SERVICE BULLETIN

Subject: GS-X Nexgen Rear Display Upgrade Package**Date: 8/18/10****Bulletin No. SB10-10**

Nexgen Rear Display 47-861048-000

Figure 1 - Modified CPU with Heat Sink

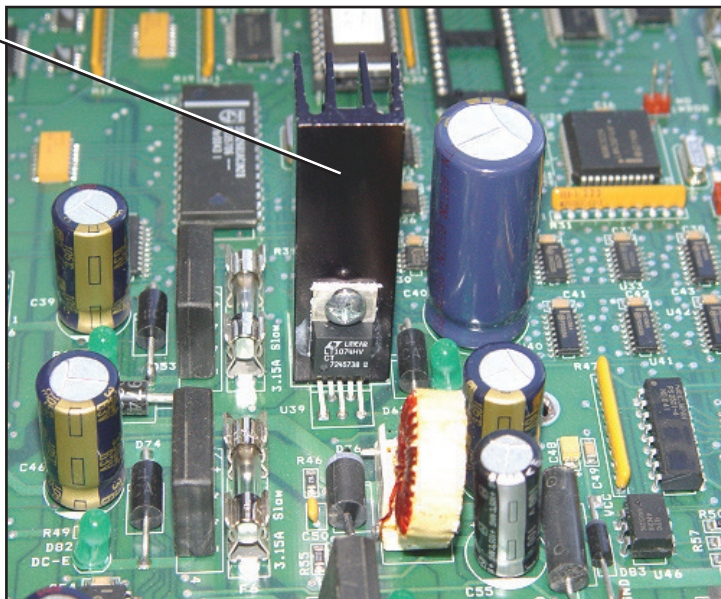
1. Disconnect power to the pinsetter by turning off the main power switch and unplugging the power cord to the Nexgen Box.
2. Locate the CPU PCB board and check if Regulator U39 has a black heat sink attached and is soldered on the board. Refer to *Figure 1*.

- a. If the CPU PCB has the heat sink soldered onto the board, the board will operate as needed and the Rear Display package can be installed.
 - b. If the CPU board does not have this heat sink, it will need to be modified as it will not communicate with the Rear Display unit.
3. If a heat sink is not present, the CPU PCBs will need to be exchanged with upgraded PCBs. To receive exchange PCBs, contact the Brunswick Electronic Repair Center or an authorized Exchange Depot. Please note that an exchange fee will be charged for each board. You can contact the Electronic Repair Center by calling 1-800-937-2695 or 231-725-4966, or sending an e-mail to erc@brunbowl.com to receive a CPU upgrade replacement and current pricing information.

Figure 1 - Modified CPU with Heat Sink

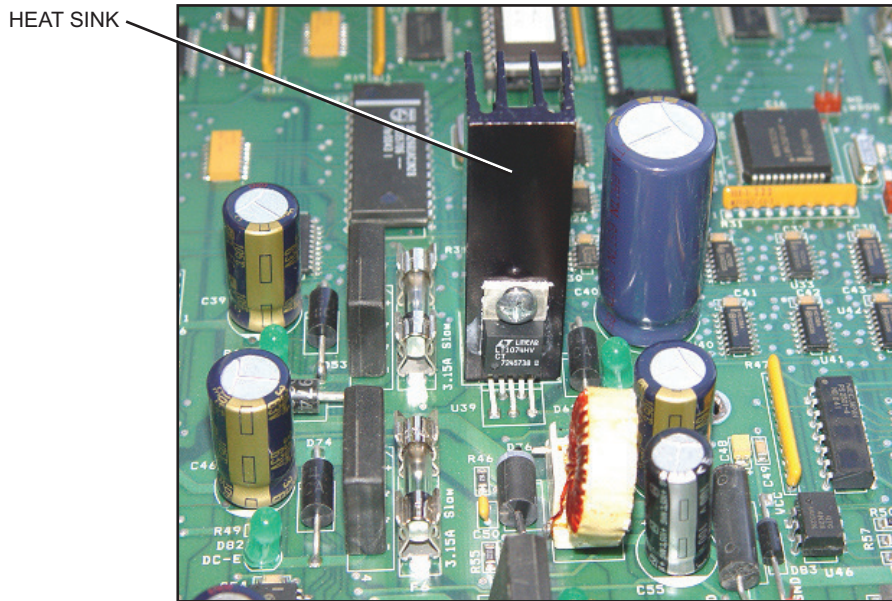
2. Locate the CPU PCB board and check if Regulator U39 has a black heat sink attached and is soldered on the board. Refer to *Figure 1*.

- a. If the CPU PCB has the heat sink soldered onto the board, the board will operate as needed and the Rear Display package can be installed.
 - b. If the CPU board does not have this heat sink, it will need to be modified as it will not communicate with the Rear Display unit.
3. If a heat sink is not present, the CPU PCBs will need to be exchanged with upgraded PCBs. To receive exchange PCBs, contact the Brunswick Electronic Repair Center or an authorized Exchange Depot. Please note that an exchange fee will be charged for each board. You can contact the Electronic Repair Center by calling 1-800-937-2695 or 231-725-4966, or sending an e-mail to erc@brunbowl.com to receive a CPU upgrade replacement and current pricing information.
